**ADDENDUM NO. 3**

**PROPOSAL FOR FURNISHING ALL LABOR, MATERIALS, EQUIPMENT, TRANSPORTATION, SUPERVISION, PERMITS, ETC. NECESSARY FOR THE NIRC – BUILDING 28 CARGO ELEVATOR INSTALLTION, LOCATED AT THE UNIVERSITY OF LAFAYETTE CAMPUS IN NEW IBERIA, LOUISIANA.**

**Due Thursday, January 18, 2024 10:00 AM Solicitation No. 24210**

*d+b Architecture*  
 January 11, 2024  
 Addendum No. 3  
 Attachment No. 1

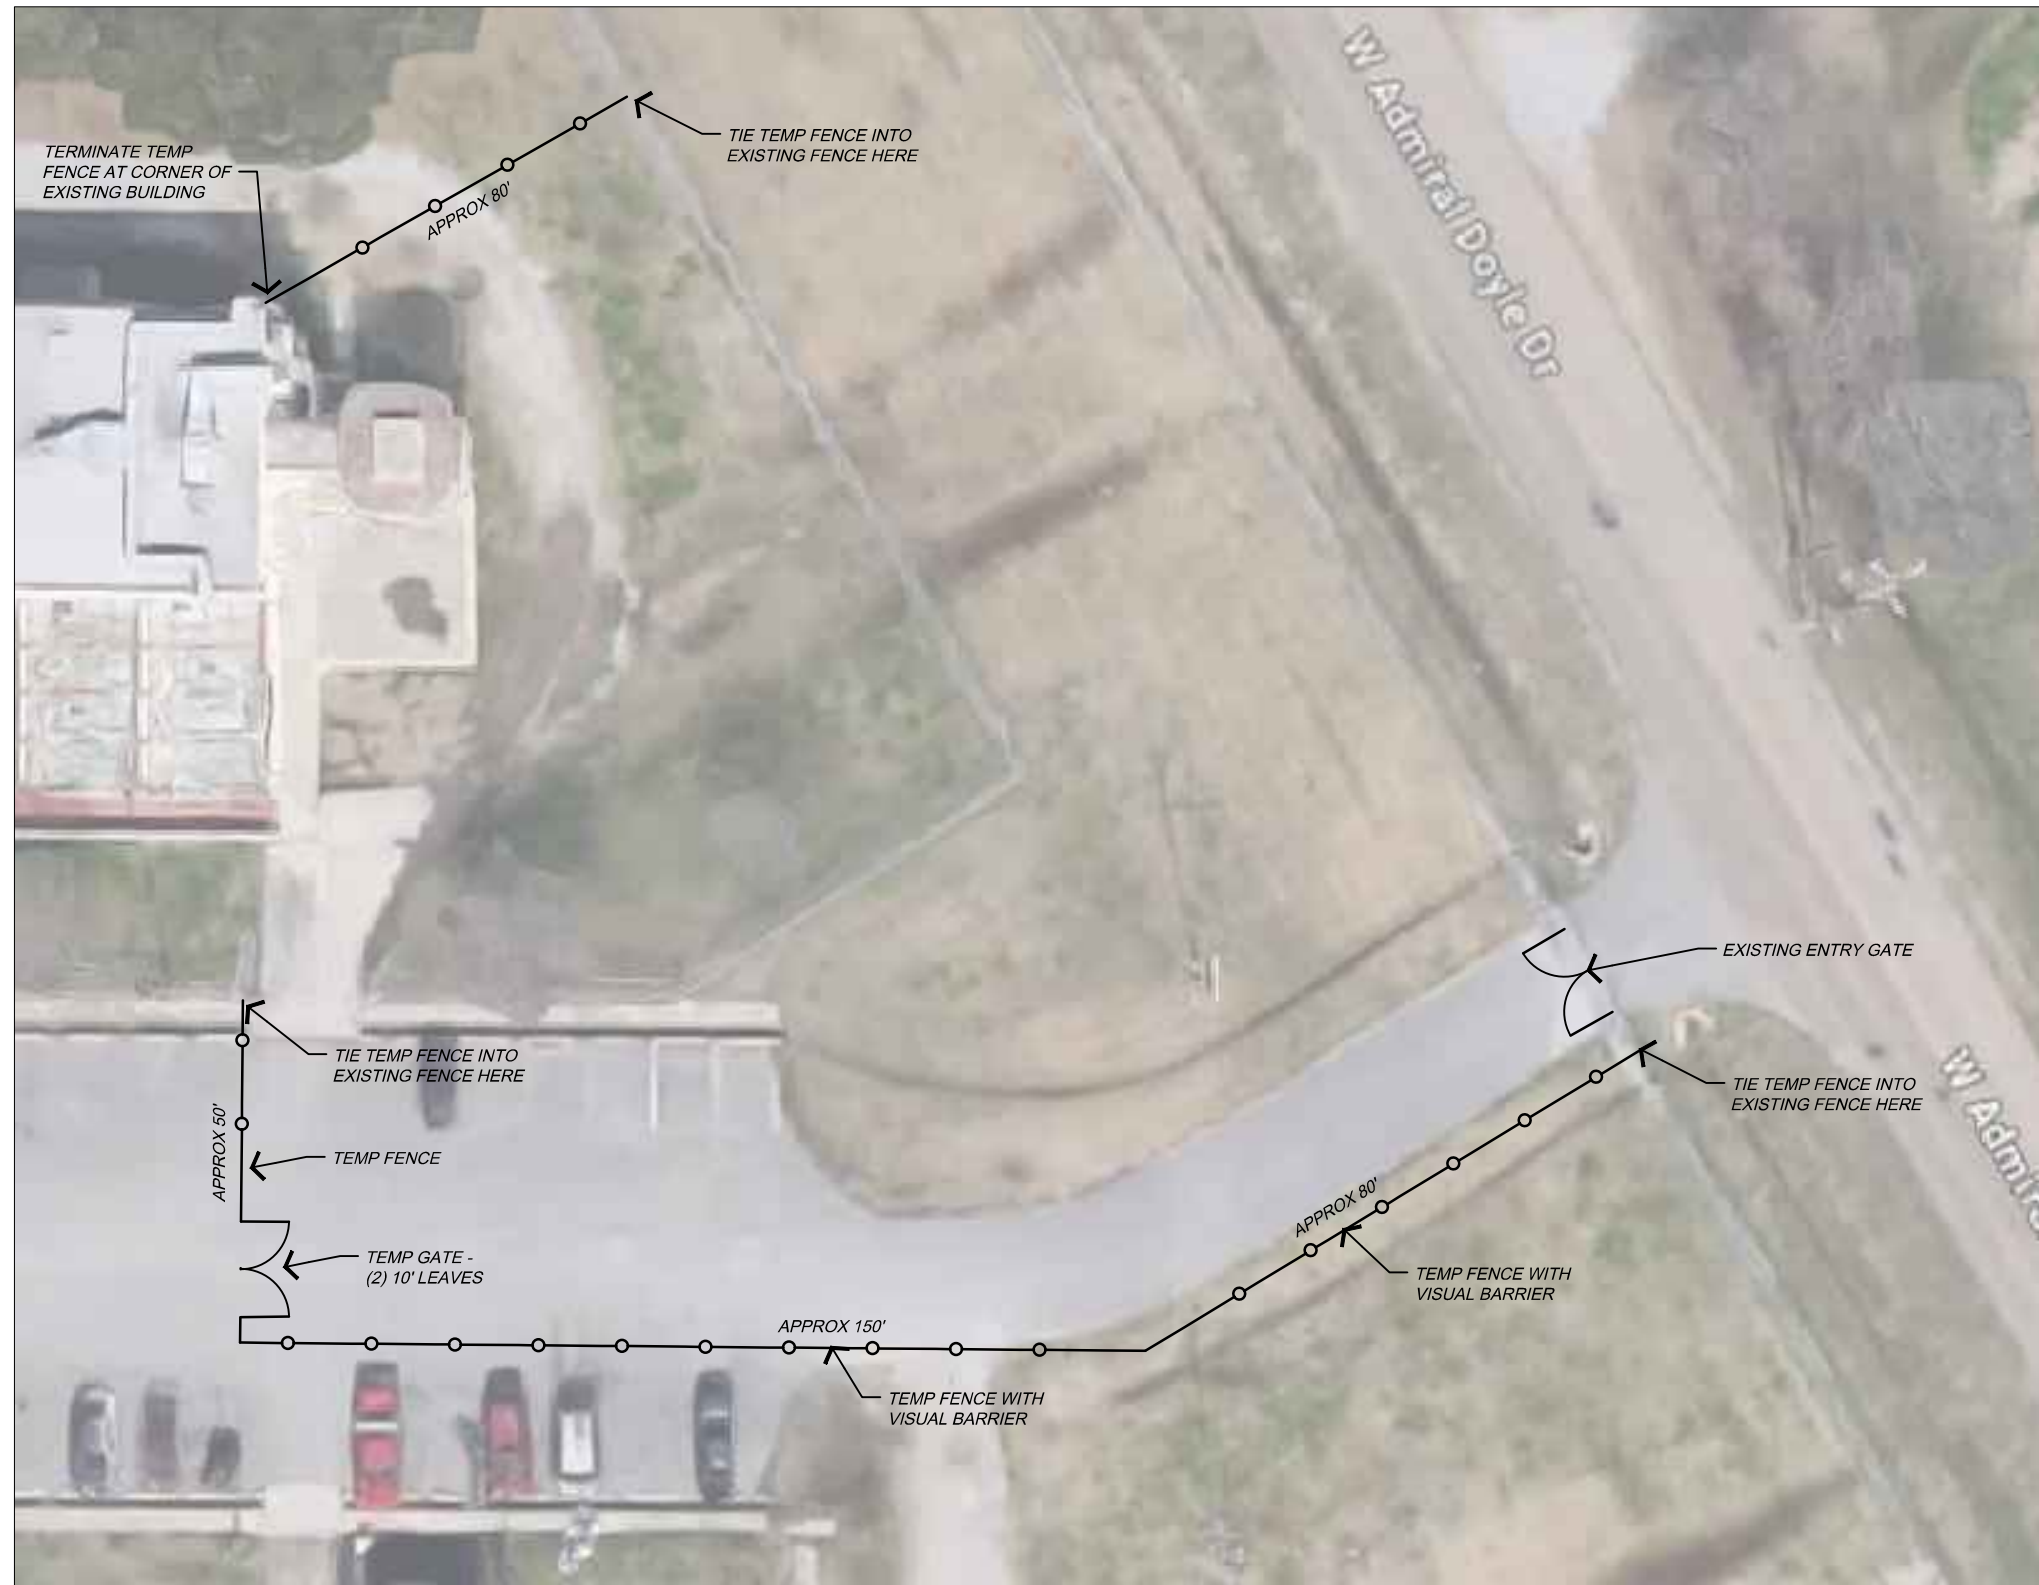
**Item No. 1 - A0.1:** Provide temporary fencing, 6' high minimum, as per the attached sketch. Note that 150' + 80' of the temporary fencing shall also provide a visual barrier. See attachment No. 1
